AGENDA
City of Gig Harbor Design Review Board
Virtual Meeting of June 10, 2021 at 5:00 pm

- I. **Call to Order:**
 - II. **Roll call:**
 - III. **Approval of Minutes:** May 27, 2021
 - IV. **Agenda Items for Formal Review**
 - a. Announcement of Application
 - b. Open Public Meeting Announcement
 - c. Appearance of Fairness Issues
 - d. Staff Report
 - e. Applicant Introduction and Presentation
 - f. Public Comment (See Assistance Memo)
 - g. Discussion and Voting
-
1. **Paul Conan 3521 47th Street Ct GIG HARBOR, WA 98335: Burnham Drive Apartments:** (PL-SPR-17-0003, PL-CUP-17-0001, PL-DR-17-0184 and PL-SEPA-17-0013). The proposal includes an 78-unit apartment complex with a

community building, parking, and utility extensions on an irregularly shaped parcel of 4.45 acres. The development will include five 3-story multi-family residential buildings, a 2-story carriage unit building with garages on the first level and apartment units on the second, and a single-story community building with leasing offices. The site is located in the City's B-2 Zoning District (General Business) and the MUD Overlay (Mixed Use District). Multiple-family Dwellings are a conditional use in this zone a

GRADING PLAN

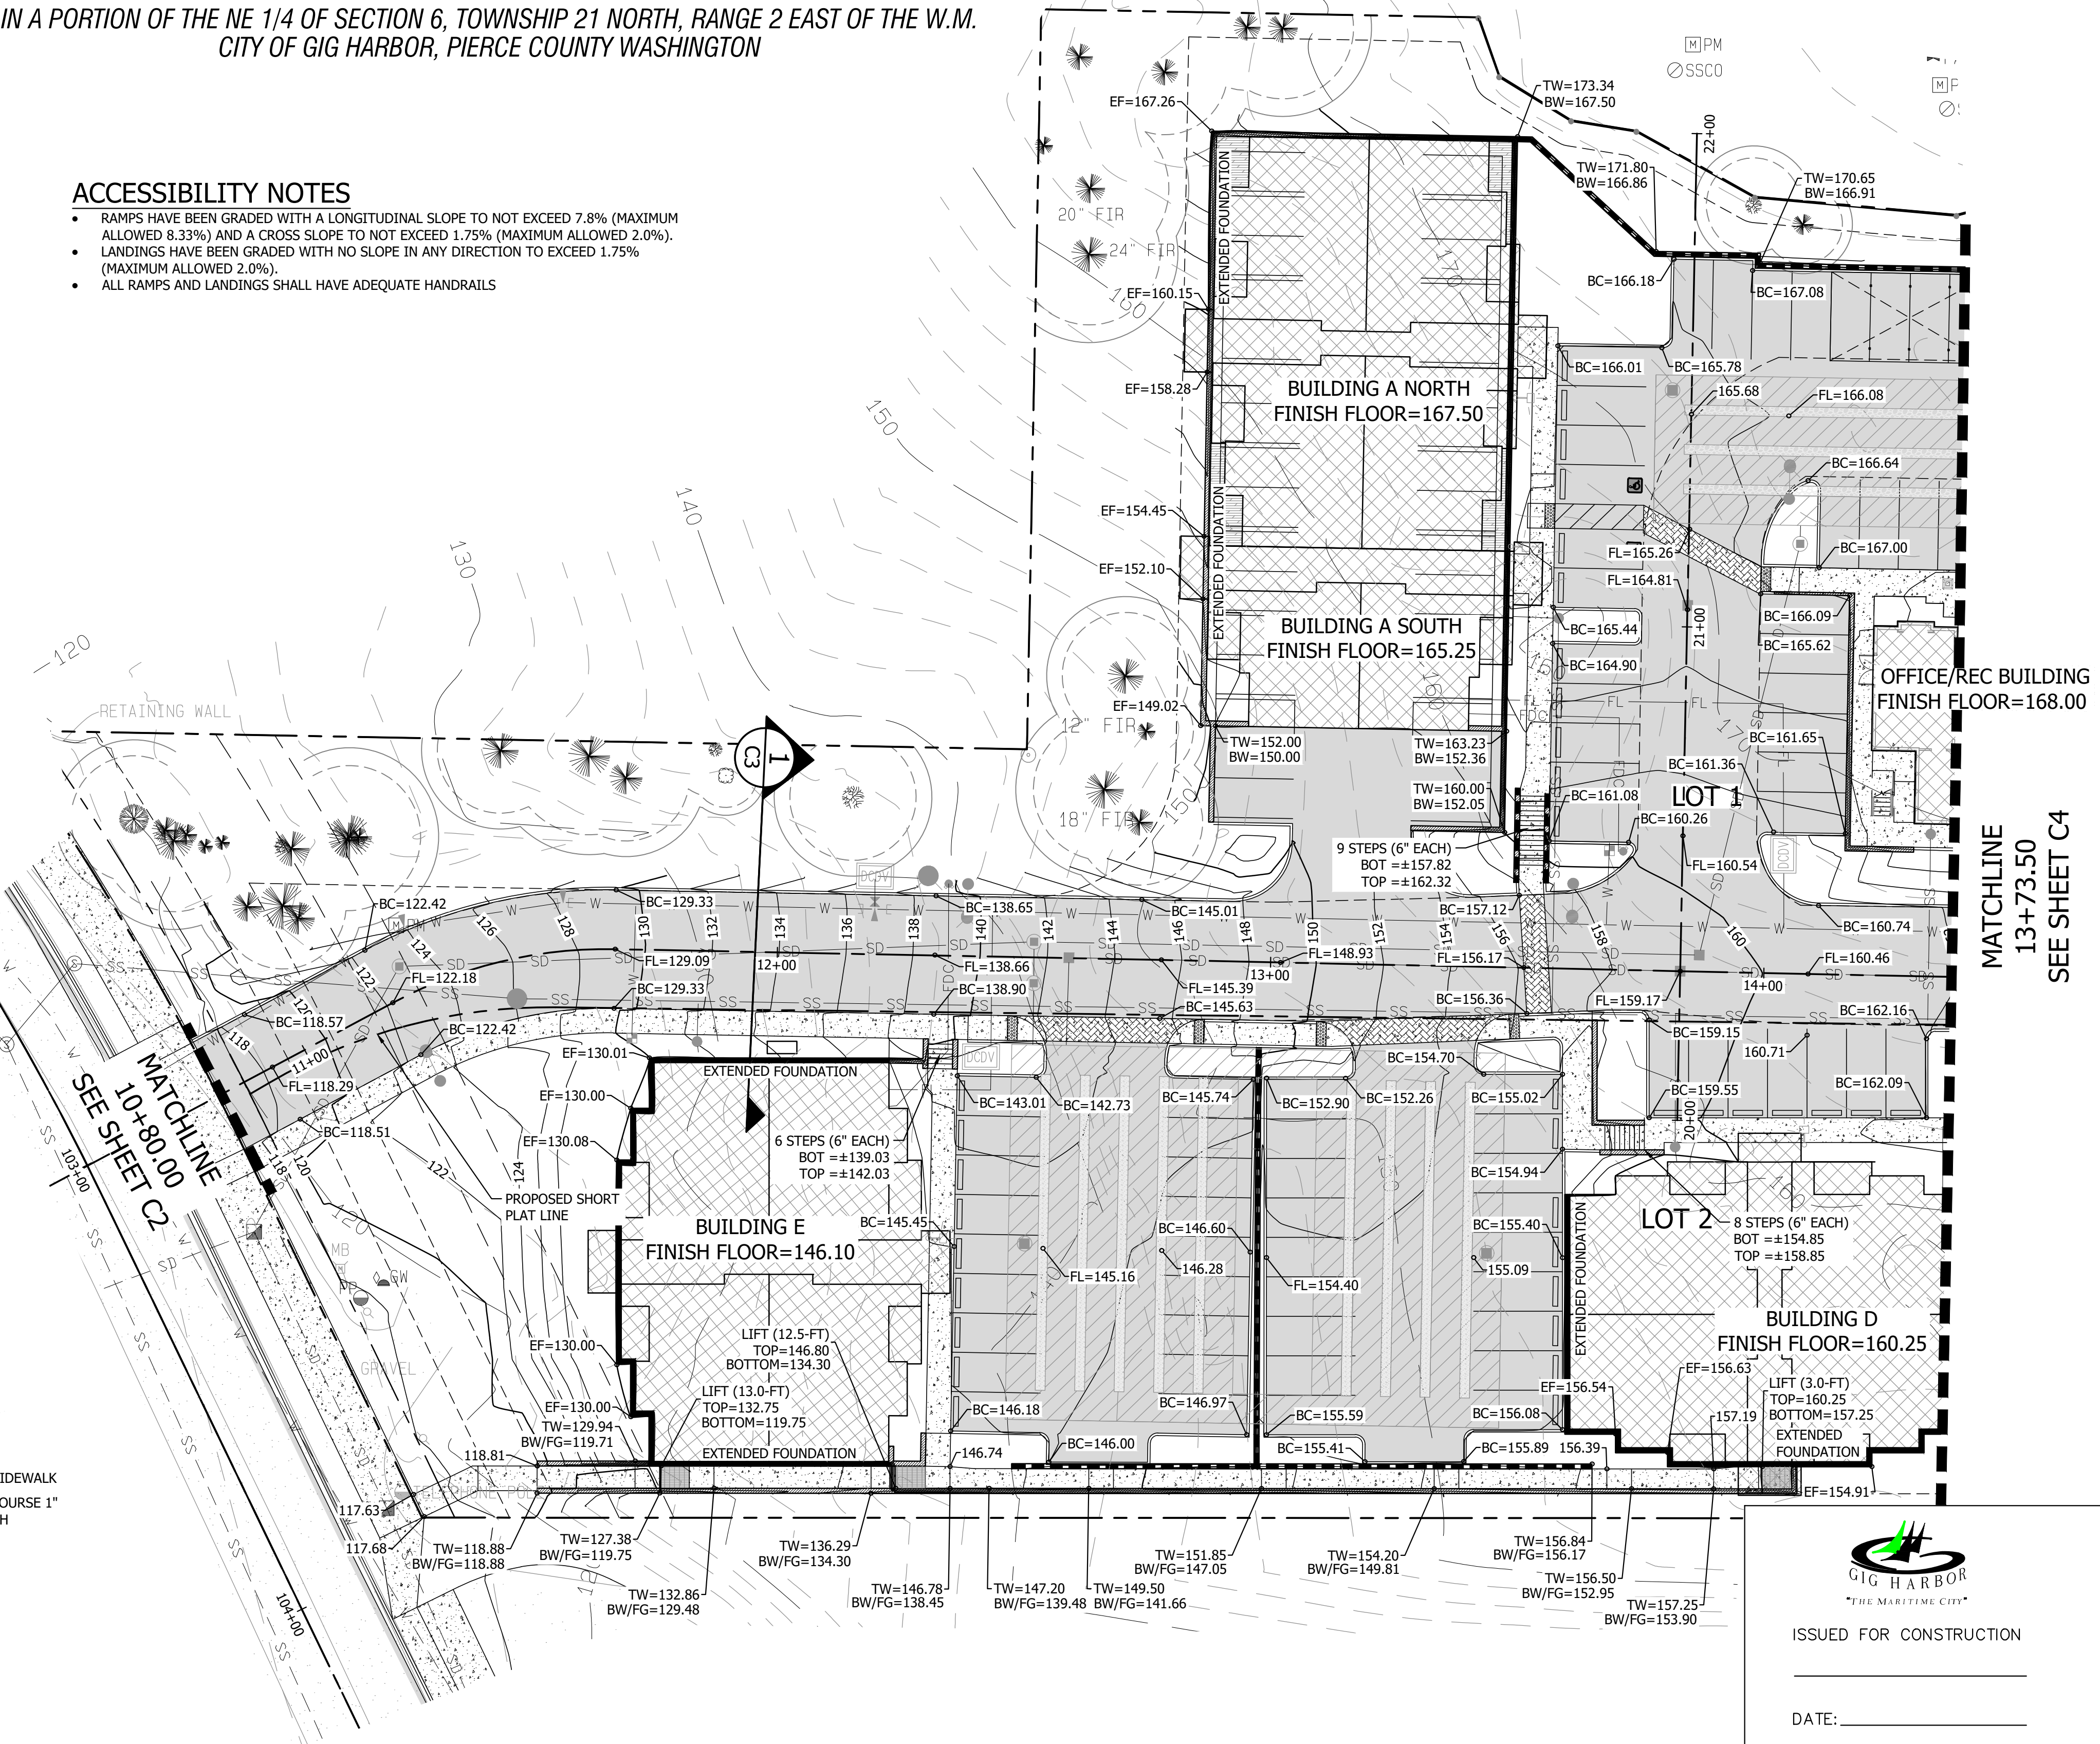
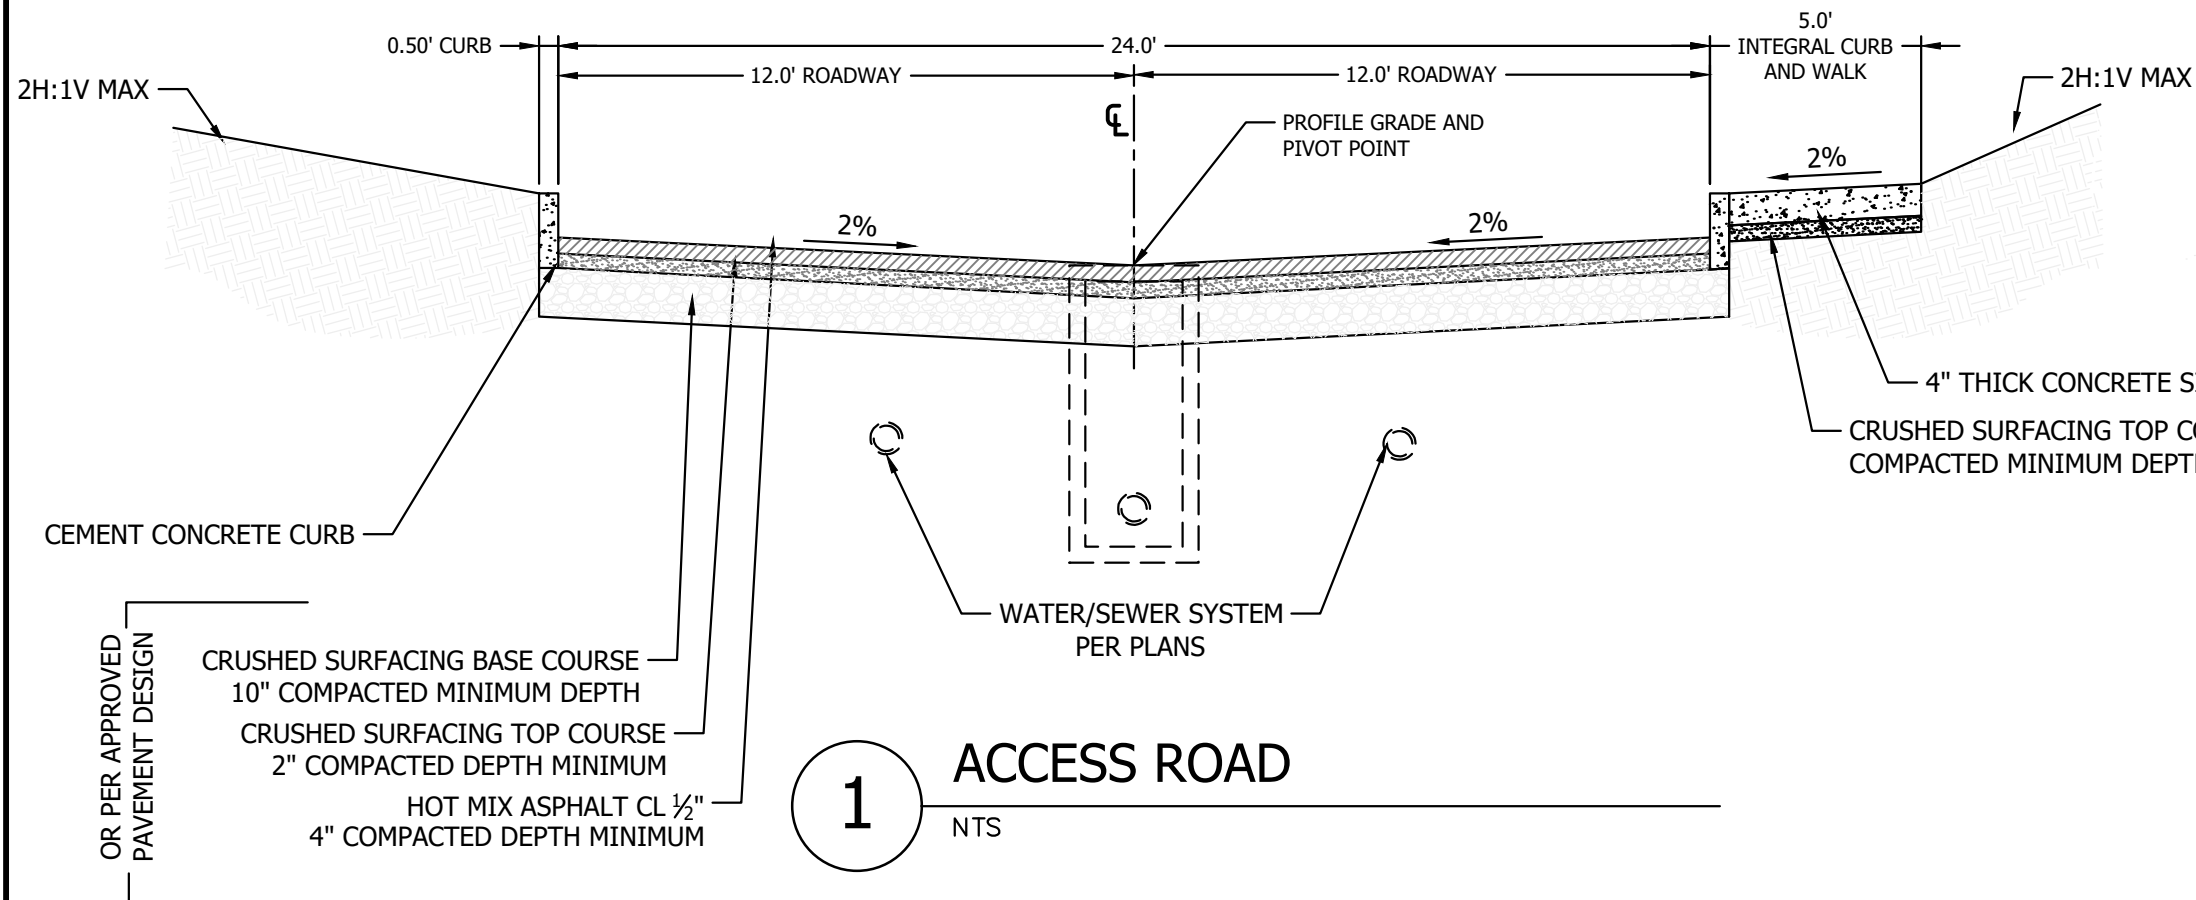
and development process. Please see Sheet C3 of Exhibit B for the applicant's proposed Grading Plan.

- A 14% difference in cut and fill quantities, as represented on sheet C3 of Exhibit B;
 - An increased difference in cut and fill quantities of up to 20%, provided that the current site design incorporating a "stepped" building (Building B) and lower-level parking garage is maintained, and further provided that the increase in grading does not result in a change to the finish floor elevations presently designed in Exhibit B.
